**Providence City
Administrative Land Use Authority
Agenda – Thursday, March 25, 2019 10:00 AM
Providence City Office Building
164 North Gateway Drive, Providence UT 84332**

Item No. 1. Conditional Use – Site Plan: The Providence City Administrative Land Use Authority will consider for approval a request by Jeremy White for approval of a conditional use site plan for a detached accessory boat storage garage located at 865 E Canyon Road, Providence UT.

Item No. 2. Conditional Use – Site Plan: The Providence City Administrative Land Use Authority will consider for approval a request by Nate and Katie Stokes for approval of a conditional use site plan for a single-family residence located at 668 E 400 N, Providence UT.

RE: Conditional Use Review, Stokes Home, 668 East 400 North, Providence Ut.

SHEET TITLE
SITE PLAN
SHEET NUMBER
SD100

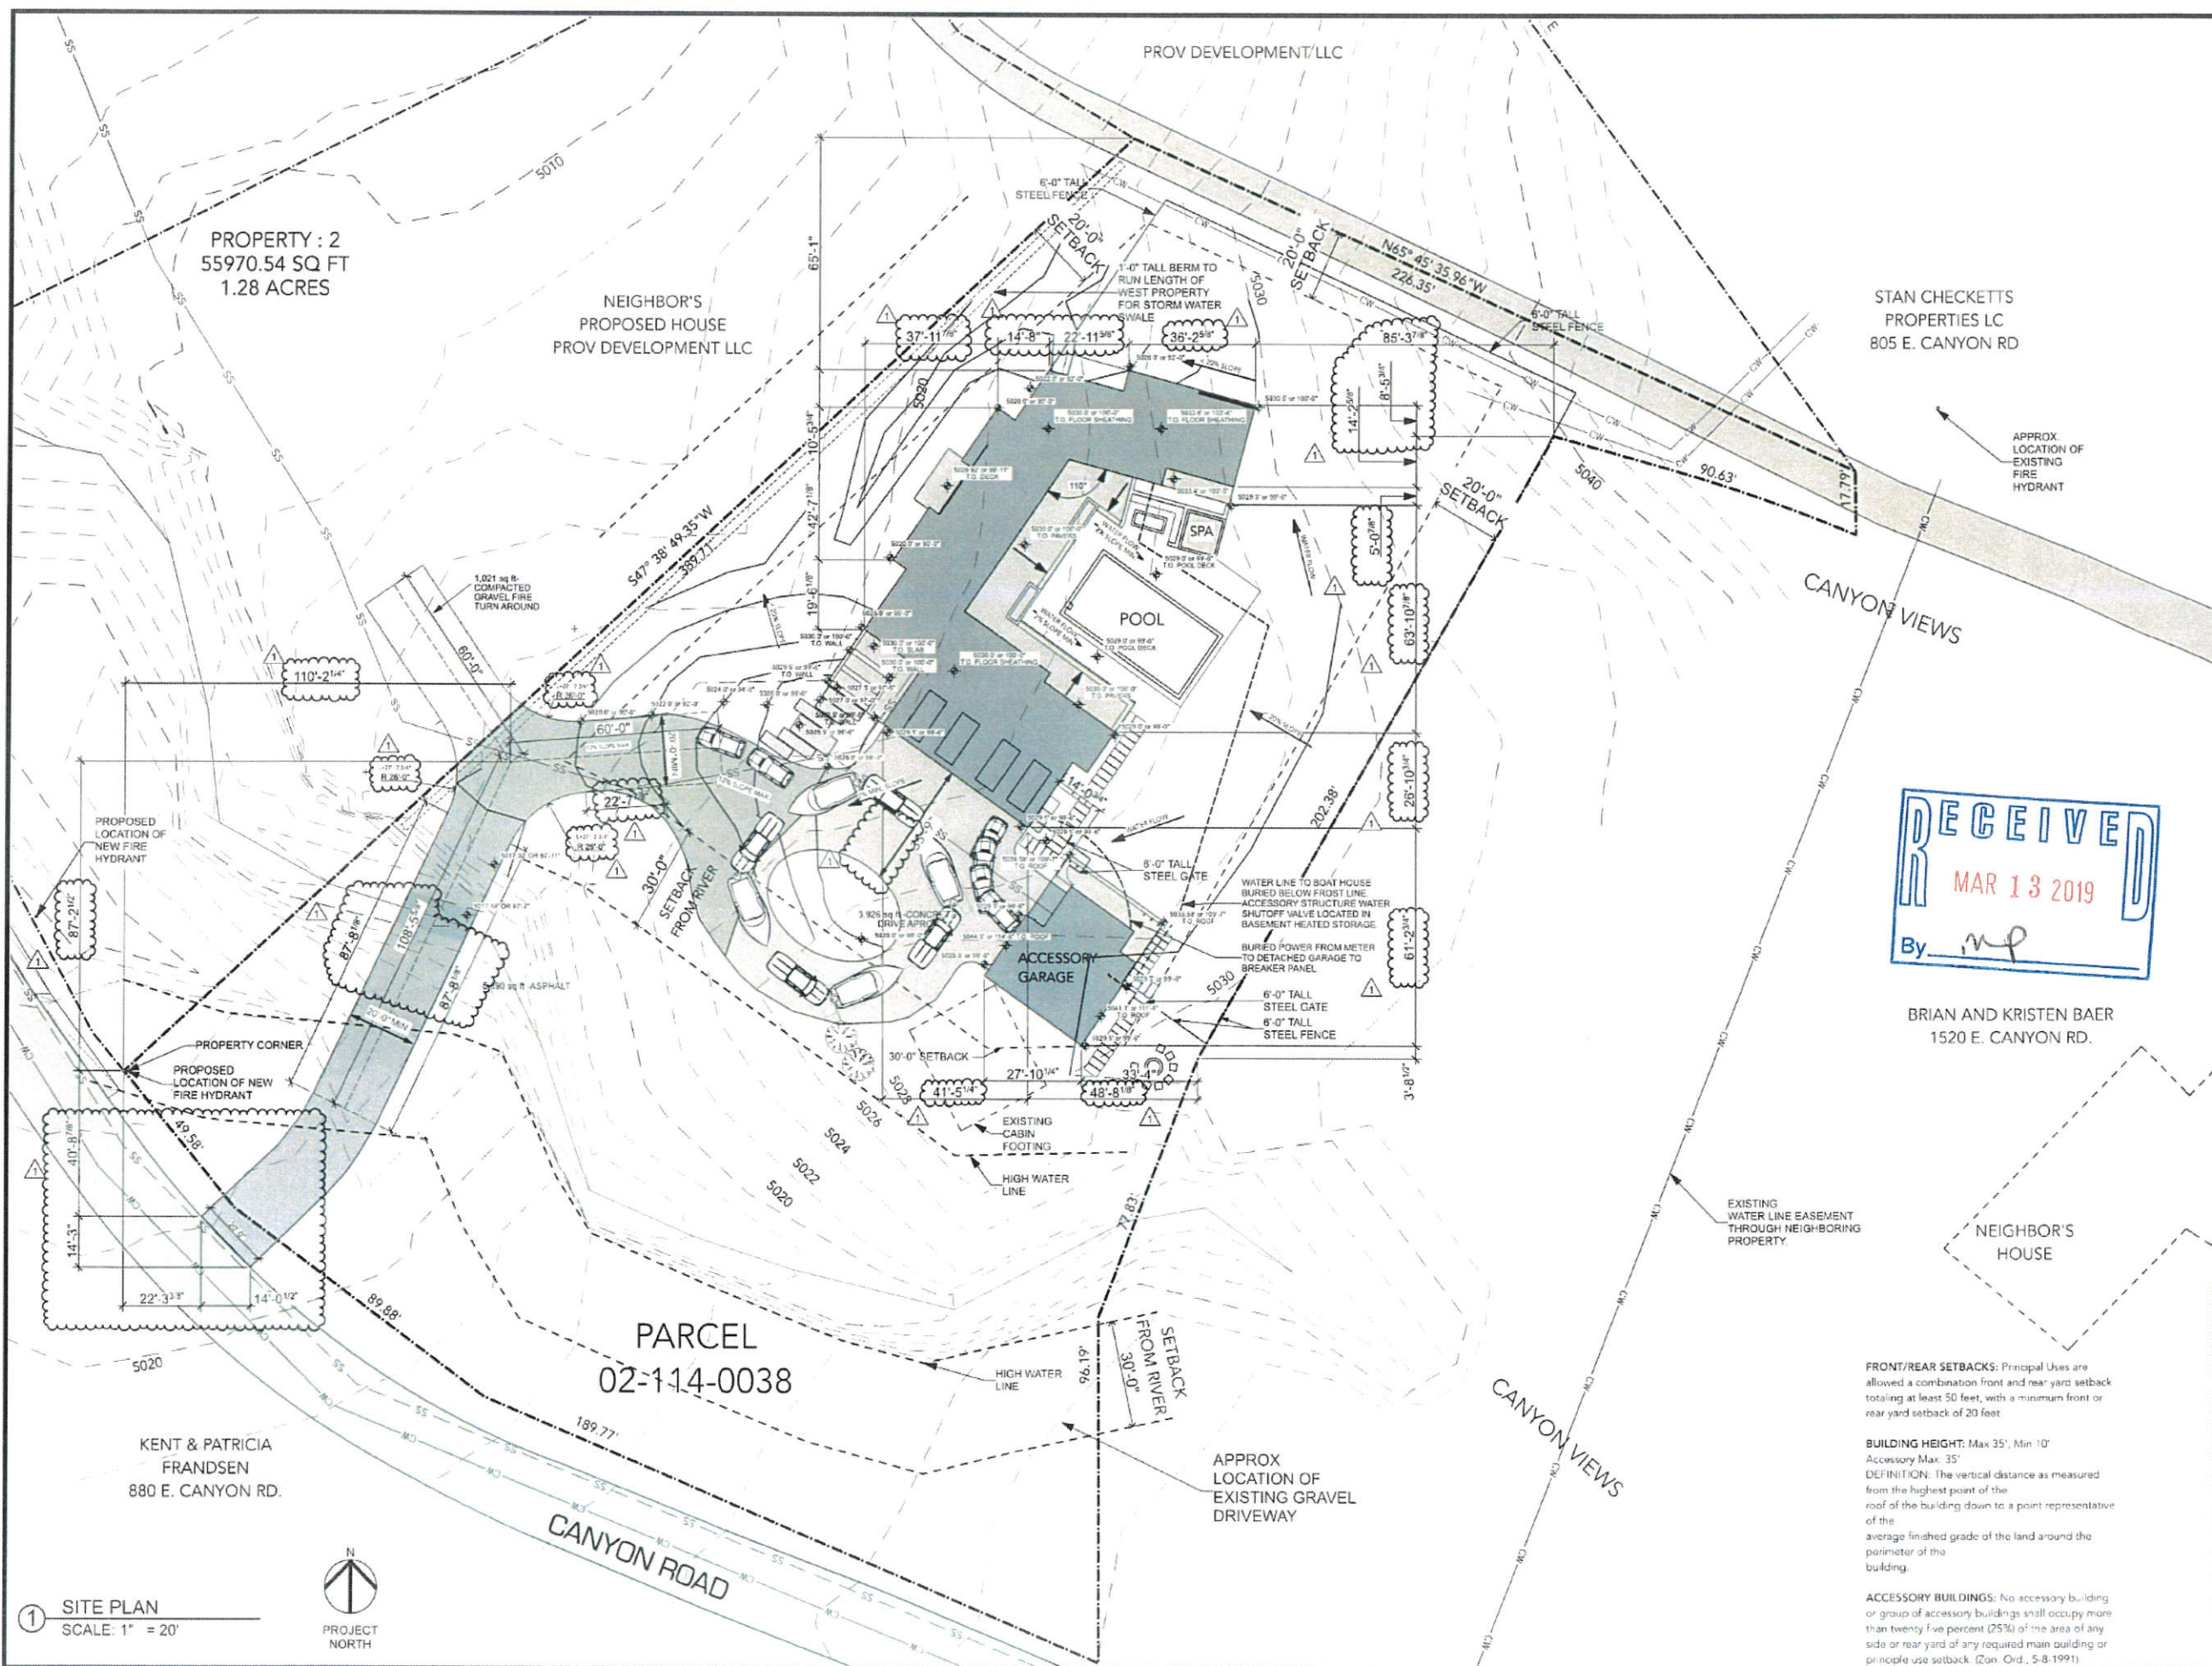
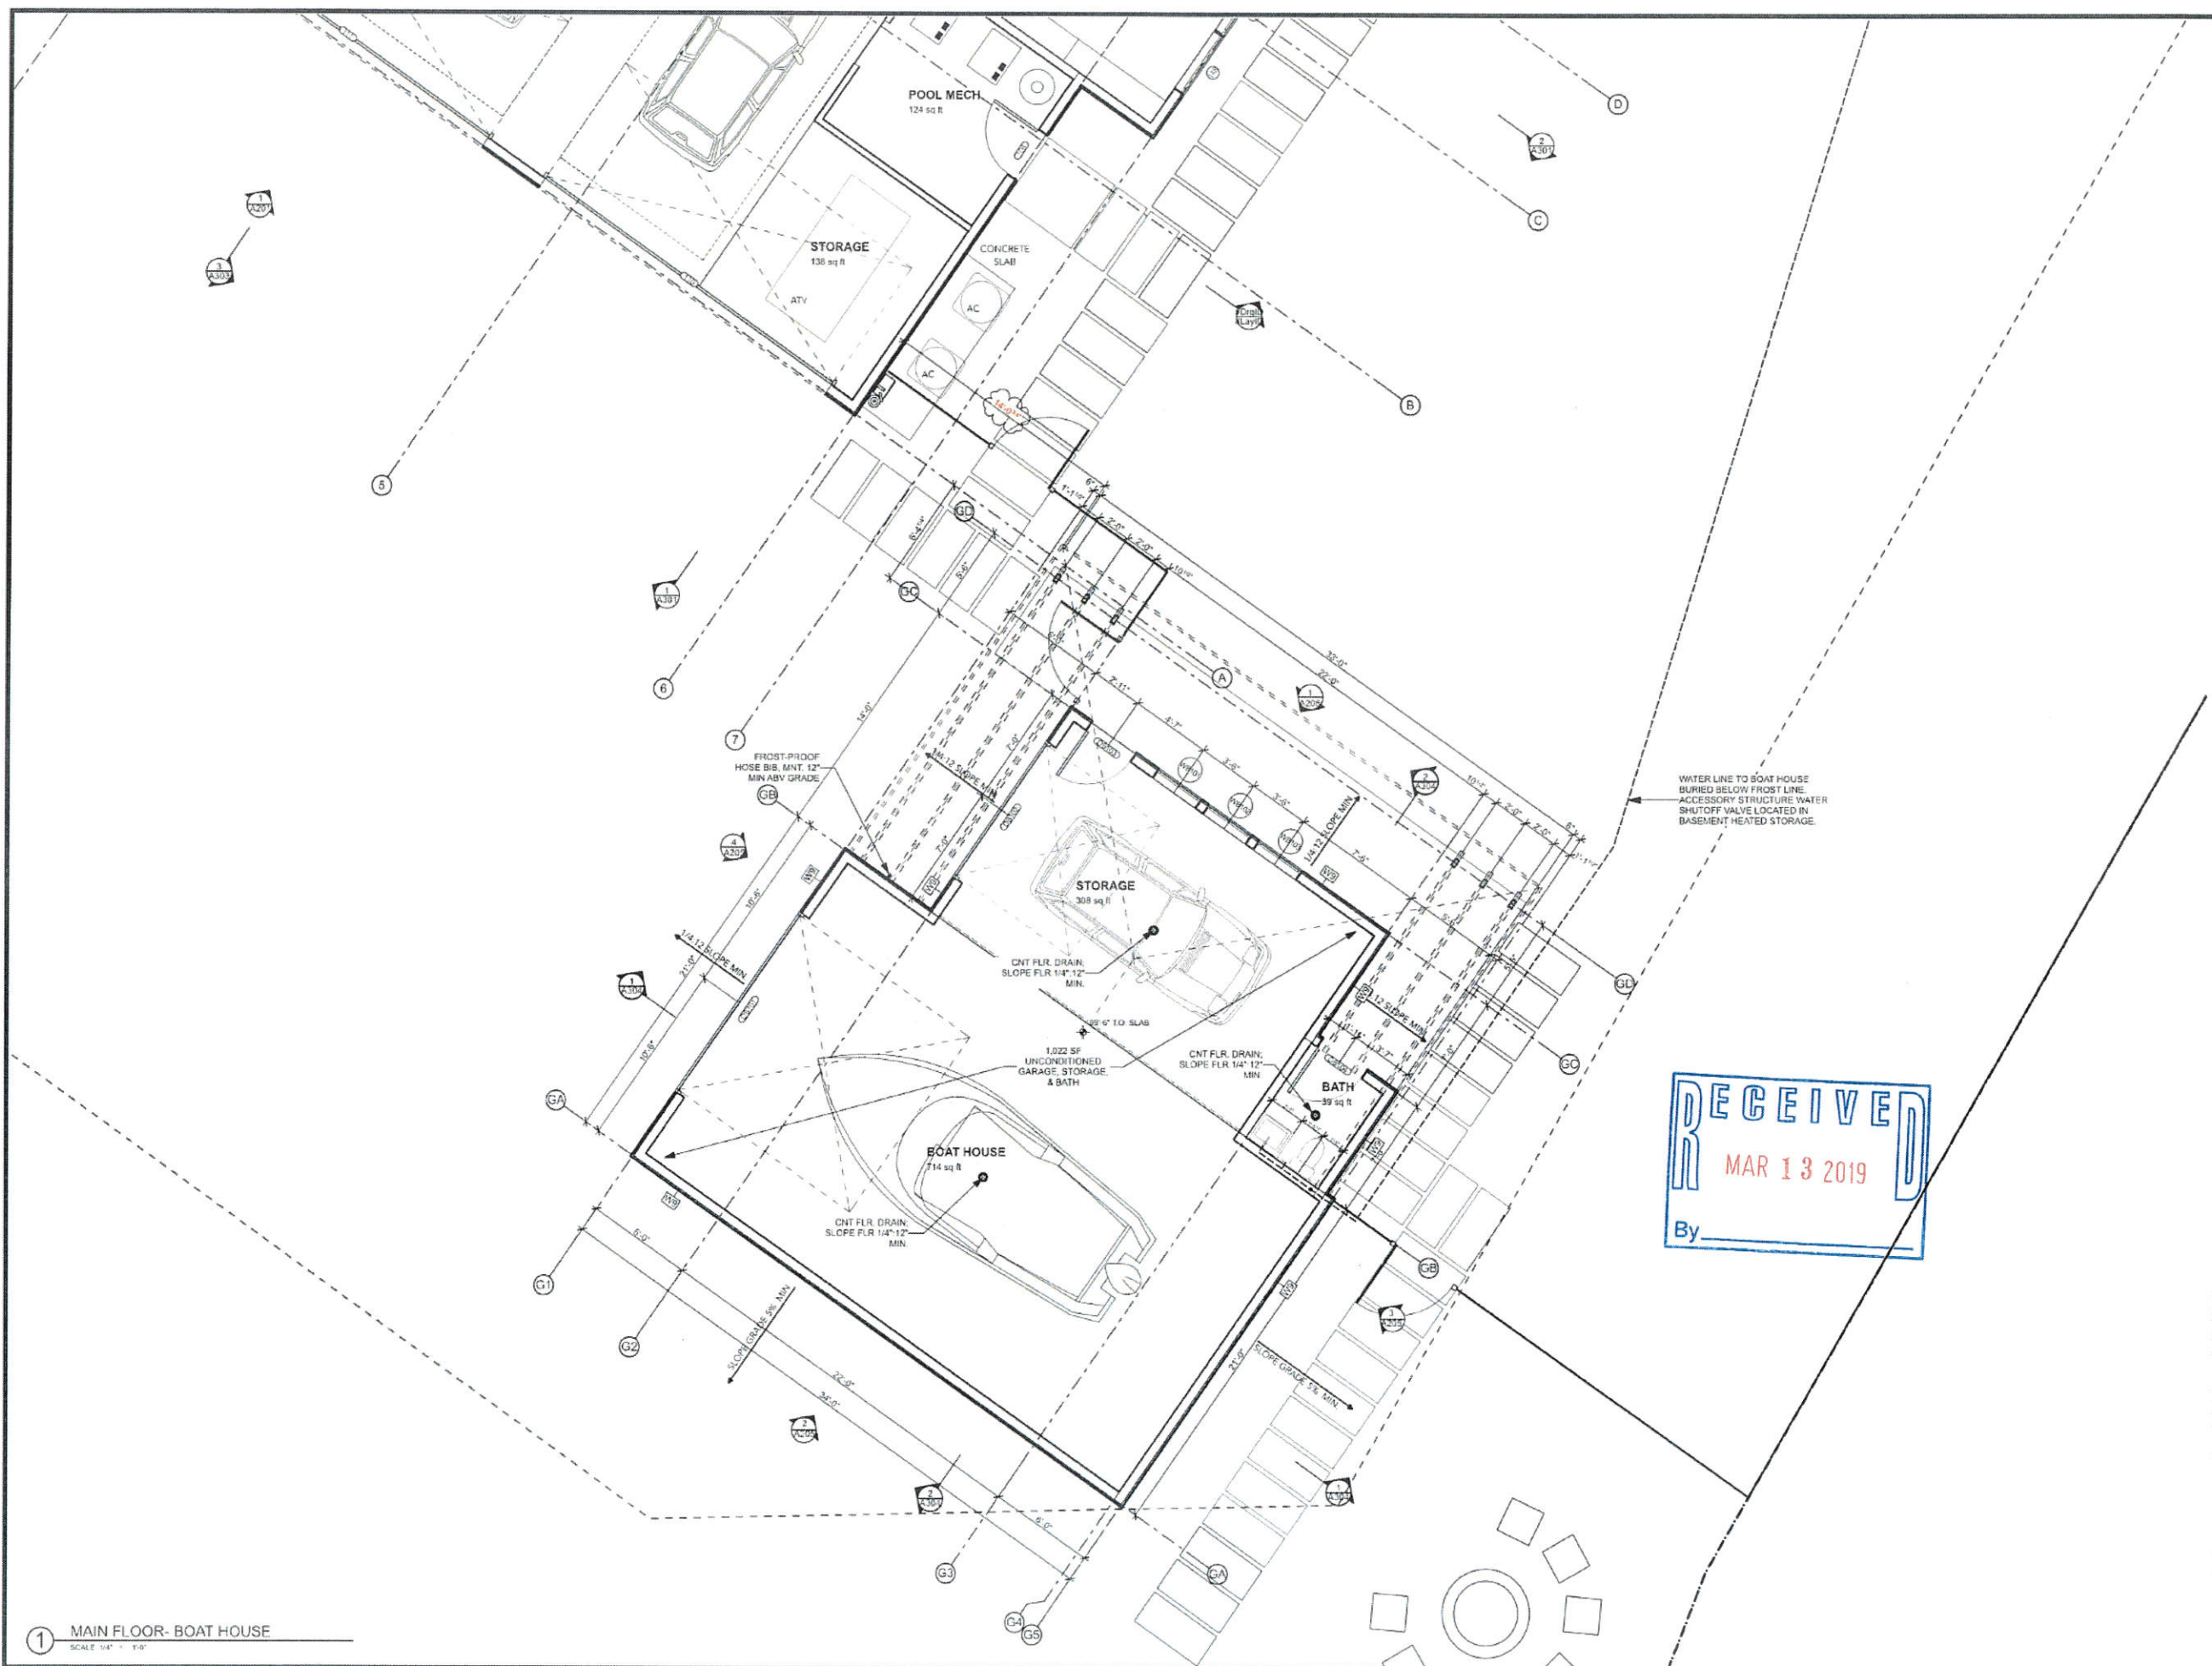
- No grade exceeds the 20% slope within 50 feet maximum. See grade slope notes shown on the attached site plan SD100

- As proposed, all structures shall be constructed a minimum of 30 feet from the creek's high water mark. See creek setback shown on attached site plan SD100.

SITE PLAN
SCALE: 1" = 30' - 0"

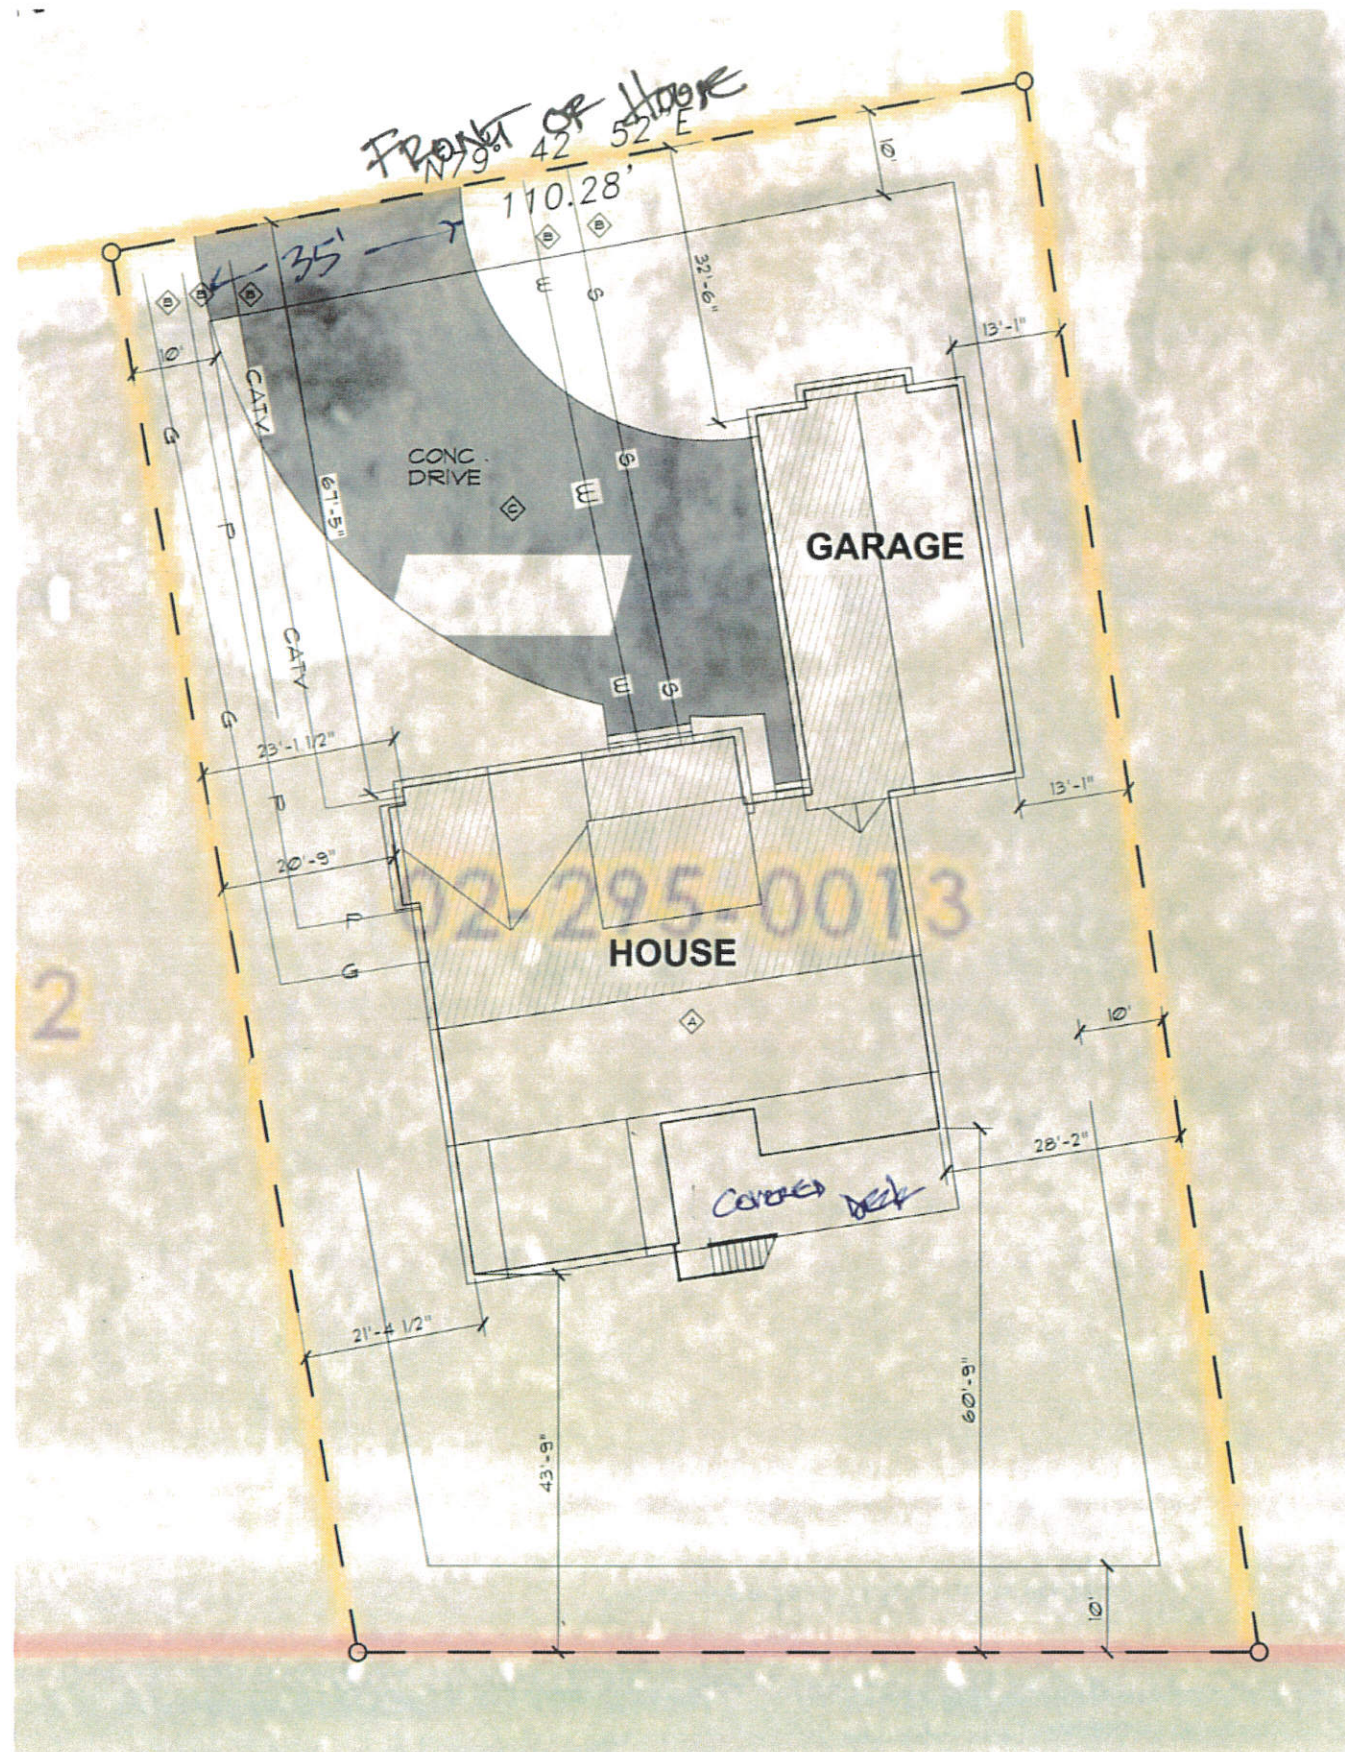
(IFC 503.1.1) Fire Apparatus Access shall extend to within 150 feet of all portions of the facility as measured by an approved route around the exterior of the building.

(IFC 507.5.1) Fire Hydrants shall be located within 400 feet of the building as measured by an approved route around the exterior of the building. Exception allows for the distance to be increased to 600 feet for R-3 occupancies.

- The building appears to be approx. 6,200 sq. ft. According to Table B105.1 the fire flow for a combined fire area 6,200 sq. ft. of type V-B is 2,000 GPM. Fire Flow requirements are subject to change due to separation of fire areas, type of construction, and the installation of fire suppression system.
- **Two fire hydrants exist within 600 feet of the home.**

- **Access approved at subdivision review**

- **Fire hydrant location approved at subdivision review**
